BEFORE THE OREGON PUBLIC UTILITIES COMMISSION

2017 Integrated Resource Plan

Docket LC 68

SIERRA CLUB'S FINAL COMMENTS

Figure 1. IPC forecasted market energy prices and Bridger Unit 4 production costs

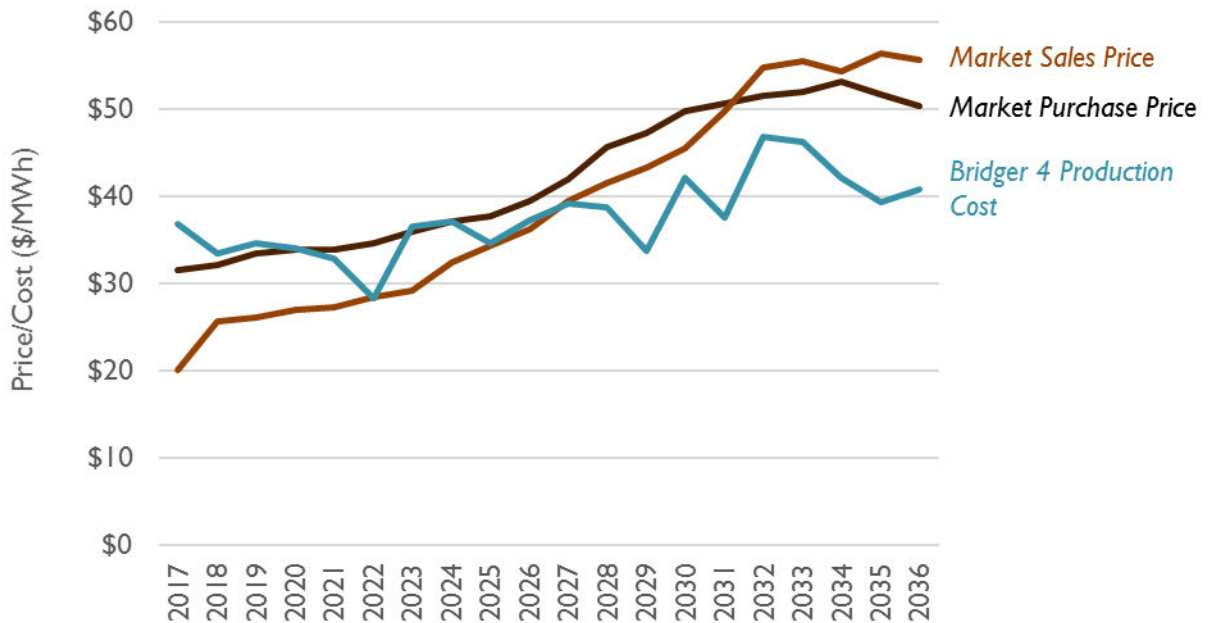
IPC devoted a section of its reply comments to the claim that “the Jim Bridger units remain economic resource options.”²⁰ However, IPC did not provide any evidence to support this claim. In contrast, Sierra Club’s opening comments demonstrate that IPC’s own modeling indicates that, even under assumptions that are unreasonably favorable to the Bridger plant, neither Bridger Unit 1 nor Bridger Unit 2 is an economic resource.²¹ Since IPC’s IRP modeling did not contain any information regarding future fixed costs at Bridger Units 3 or 4, it is not obvious what IPC’s modeling would show regarding the long-term economic status of these units. Nonetheless, IPC’s files show that, over the short term, Bridger Units 3 and 4 are both expected to incur net operational losses, without accounting for any fixed costs. Figure 1 shows that for nearly every year between now and 2025, IPC forecasts that Bridger Unit 4 will incur variable production costs that are greater than the average price IPC will receive for energy it sells on the market. The same general picture holds for Bridger Unit 3.
